Resolution 2019-25 /
Watts Remund Farms
Master Plan Amendment

**FIRST AMENDMENT OF THE
MASTER PLAN AGREEMENT FOR THE
REMUND FARM SUBDIVISION
MIDWAY CITY, UTAH**

WATTS ENTERPRISES REMUND FARMS	
AMENDED MASTER PLAN	
	BERG ENGINEERING RESOURCE GROUP PC 1014 BAYVIEW SUITE 204 MIDWAY, IA 50249 PH: (515) 651-7199
DESIGN BY: PBR DRAWN BY: CSB	DATE: 11/30/2018 REV: 2

WATTS ENTERPRISES
 REMUND FARMS
 AMENDED PHASING PLAN

EXHIBIT A

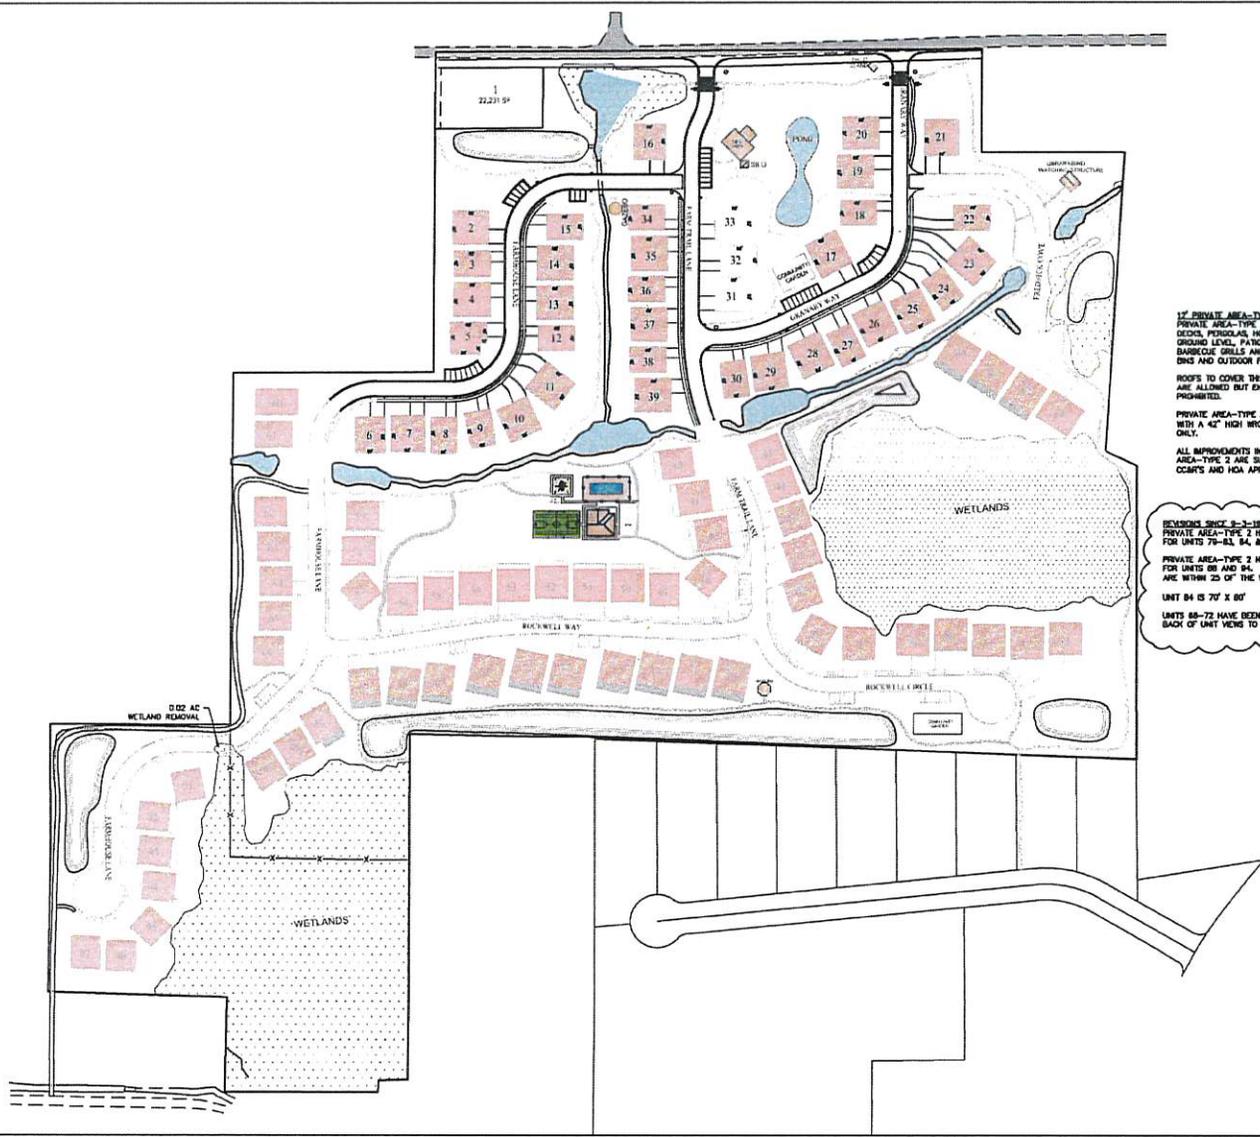
- 1. Exhibit A of the Master Plan Agreement is amended, as set forth in Exhibit A of this Agreement. Specifically, the new exhibit creates 30 private areas associated with certain lots within the development as set forth in the exhibit. The exhibit also alters the alignment of lots 84 – 87.
- 2. Section 3 of the Master Plan Agreement is amended as follows: General Description of Project.

REVISIONS SINCE 8-3-18 COUNCIL MEETING:
PRIVATE AREA-TYPE 2 HAS BEEN REMOVED FOR UNITS 74-84, 84, & 86.
PRIVATE AREA-TYPE 2 HAS BEEN REDUCED FOR UNITS 88 AND 84. NO TYPE 2 AREAS ARE WITHIN 25' OF THE WETLANDS.
UNIT 84 IS 70' X 80'
UNITS 88-72 HAVE BEEN ROTATED FOR BACK OF UNIT HERE TO THE TAPPOGOS.
